East Port Water Reclamation Facility Expansion

CCU Change Order Request
East Port WRF Expansion - Poole and Kent
Change Order #4

Subject: PCO 30- Changes to the effluent boxes on Clarifier #3 & #4
P&K PCO No. 30

Subject: **PCO 32- Additional 90 on Existing Ox Ditch Effluent piping to Diversion box**
P&K PCO No. 32

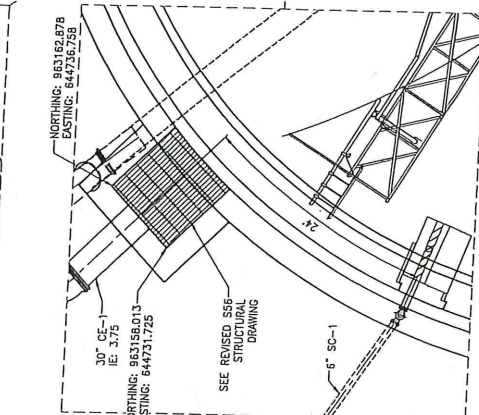
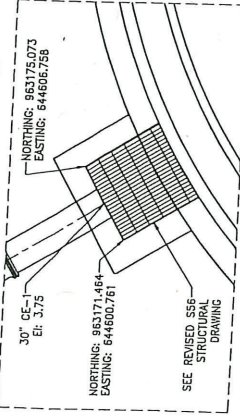
In regards to the 30" effluent lines at Clarifiers 3 & 4, PK potholed to expose both "connection" points. Neither are what is indicated on the drawings. Clarifier #3, the tee is orientated differently from what is shown. Clarifier #4, there is no tie in point, we exposed just pipe, no tee or fittings to connect to. Please see the attached drawing for reference. This is an active line with no way to isolate. For Clarifier #4, advise on how to tie into this line. For Clarifier #3, please advise on how to revise the piping to make the existing connection work or supply us on degrees and angles to rotate the clarifier effluent box to make the connection work.

- Lastly, there also is no 42" x 30" reducer on this line where shown. Potentially 3 or 4 30" effluent lines off the clarifiers will be tying into the same 30" common pipe. Please confirm this is acceptable with flow calculations.

is Described Below or in the Attached: Please refer to the attached PDF pages 2 and 3 for the revised configuration.
The clarifier outfall boxes will be rotated and approximately 3 feet deeper to accommodate the vertical and horizontal alignment to the existing pipe Tie-In locations

NOTES: 1. An additional 30" - 45 degree bend will be required as part of this revision.

2. The Scum Pit box orientation will need to be adjusted as shown. A formal PCM will be posted.

YARD PIPING PLAN

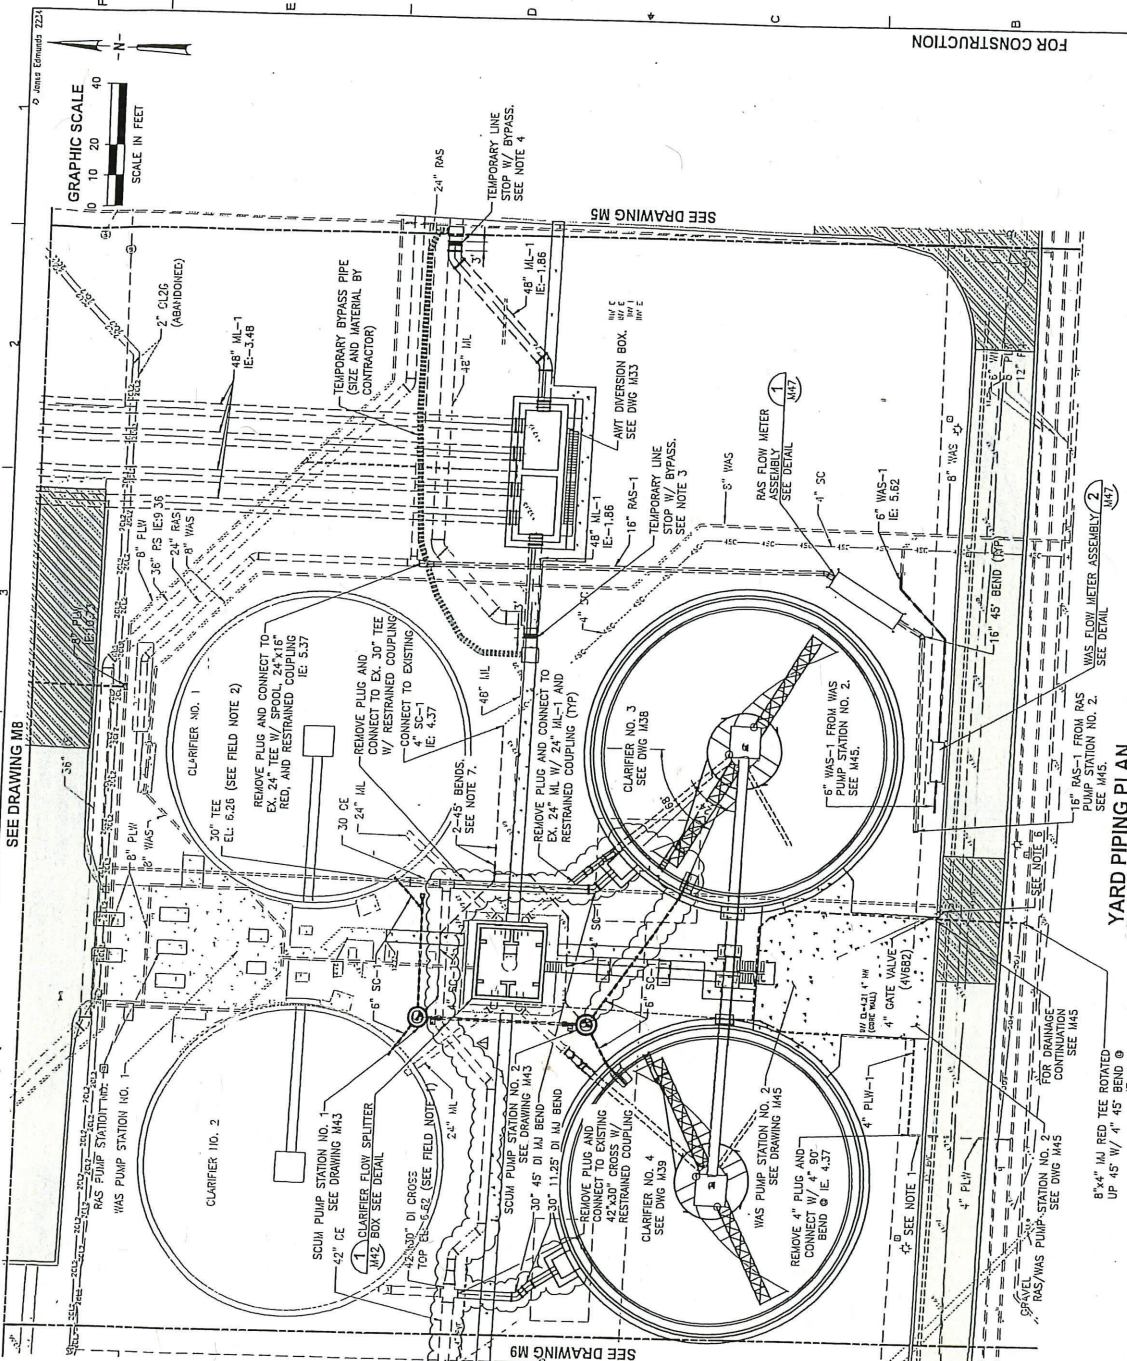
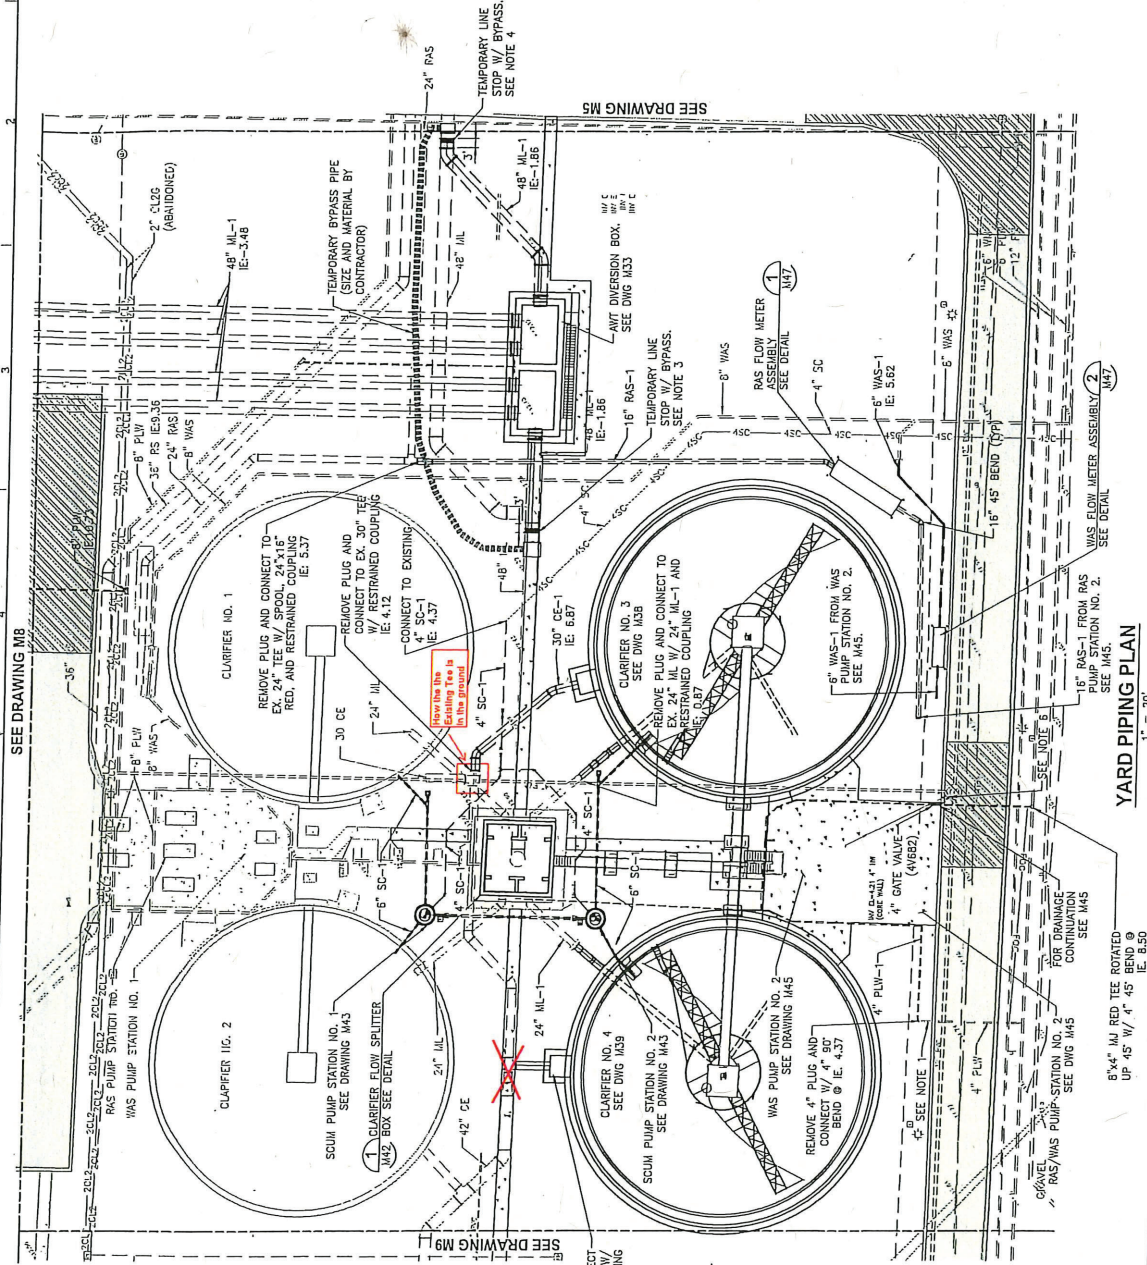
- EXISTING 42"x30" CROSS LOCATION AND ELEVATION WAS VERIFIED IN THE FIELD BY CONTRACTOR, FEBRUARY 2025. TOP OF CROSS ELEVATION IS 6.82.
- EXISTING 30" TEE LOCATION AND ELEVATION WAS VERIFIED IN THE FIELD BY CONTRACTOR, FEBRUARY 2025. TOP OF TEE ELEVATION IS 6.26.

- 2-45° BENDS FROM 6' EL. 10.45 SHOWN ON SHEET M44 TO CONNECT TO EXISTING.

- CONTRACTOR TO CUT EXISTING 48" ML PIPE, REMOVE 90° BEND, AND REPLACE WITH A PLAIN END & FLANGE COUPLING ADAPTER. PERMANENT UNDERGROUND COMPONENTS SHALL BE PAINTED PER SECTION 0900, PAINTING AND COATING.

- CONTRACTOR TO CUT EXISTING 48" ML PIPE AND INSTALL 45° BEND WITH FLANGE COUPLING ADAPTER. PERMANENT UNDERGROUND COMPONENTS SHALL BE PAINTED PER SECTION 0900, PAINTING AND COATING.

YARD PIPING PLAN

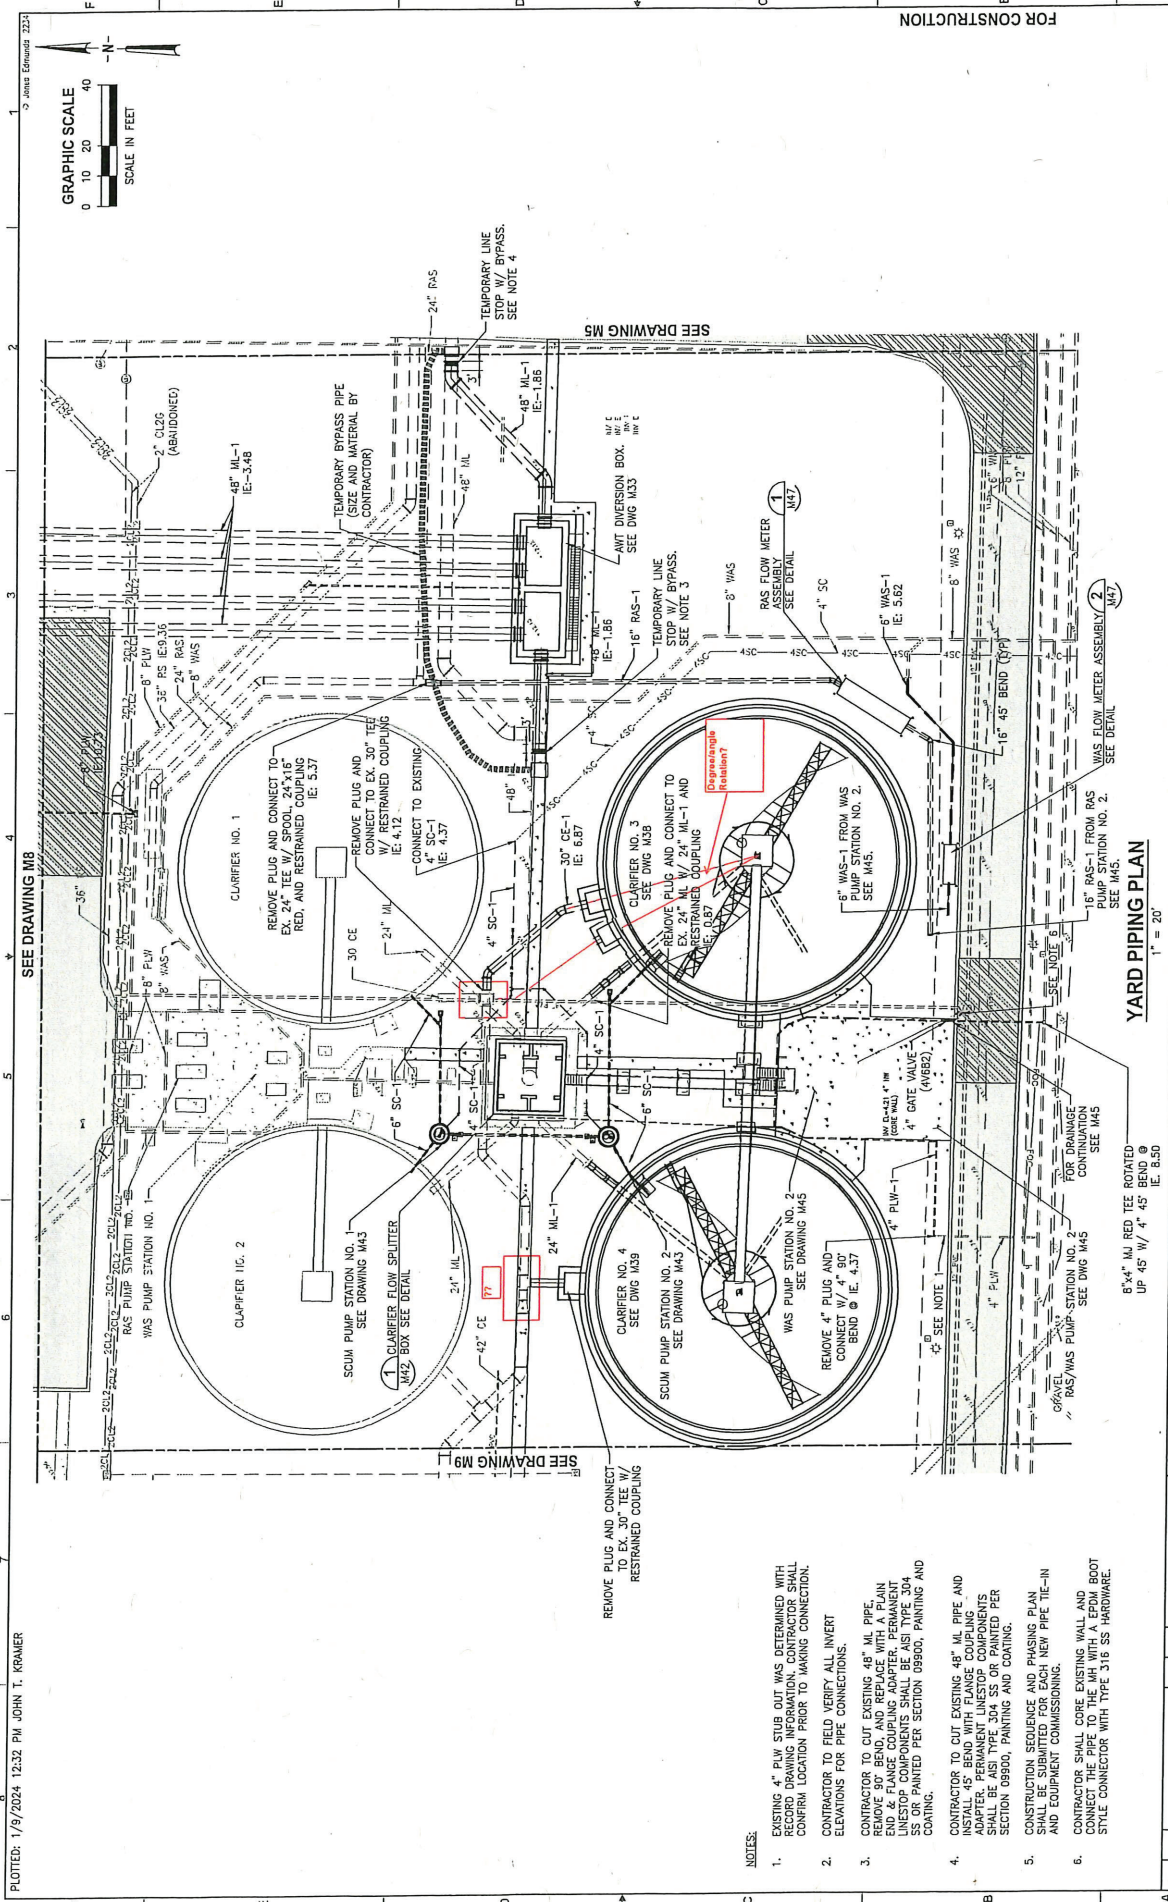
Poole & Kent prepared a cost estimate to include an additional 48" 90 and accessory kits to accommodate the location shown on the contract drawings and make the piping work with what is existing in the field. The piping and surrounding piping is different from what was shown on the drawings. We propose to incorporate the work, as clarified herein, for a lump sum increase to our contract in the amount of **\$87,223.19** and (0) calendar days to the contract completion date.
